PLANNED UNIT DEVELOPMENT

& SUBDIVISION STAFF REPORT Date: October 2, 2008

**DEVELOPMENT NAME** Sussex Place

**SUBDIVISION NAME** Sussex Place Subdivision, Lot 1, Resubdivision of Lots

# SITE PLAN

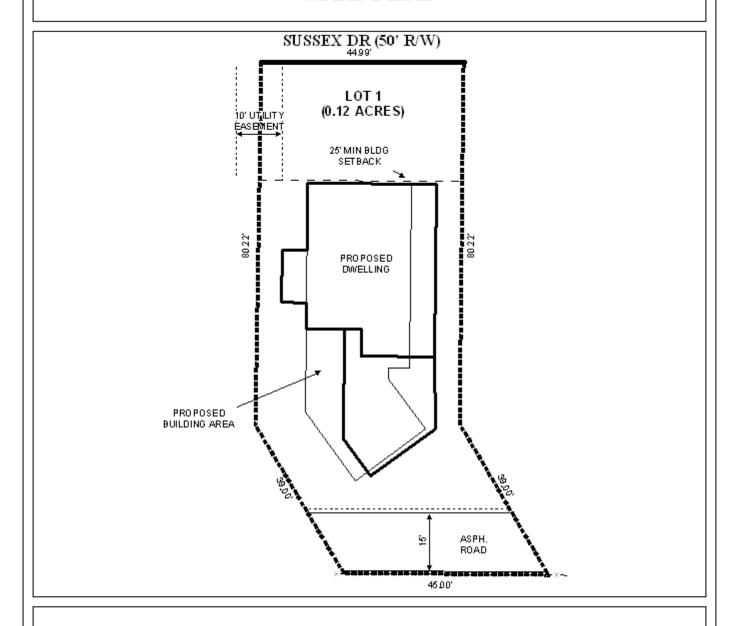
The applicant is in the process of developing the site as a single-family residence. The development of this site has, unfortunately, been exacerbated by errors and miscommunications relating to building setbacks, easements, and allowable deviations. After lengthy discussions and compromises, the applicant has revised the plan to provide a minimum setback of 5' from an interior property line, comply with easements along the other side property line, and submitted appropriate applications to amend the previously approved PUD and Subdivision.

Given the problems mentioned above, and the fact that a 5' setback is not uncommon in similar developments, revision of the previously approved plans would be appropriate.

1) Illustration of the building limits (foot print) on the final plan;

- 1) Submission of a revised PUD site plan removing the previously approved building limits and illustrating only the new building limits; and
- 2) Placement of a note on the final PUD site plan stating that it is site plan specific and any changes or alterations will require new application(s) and approval(s).
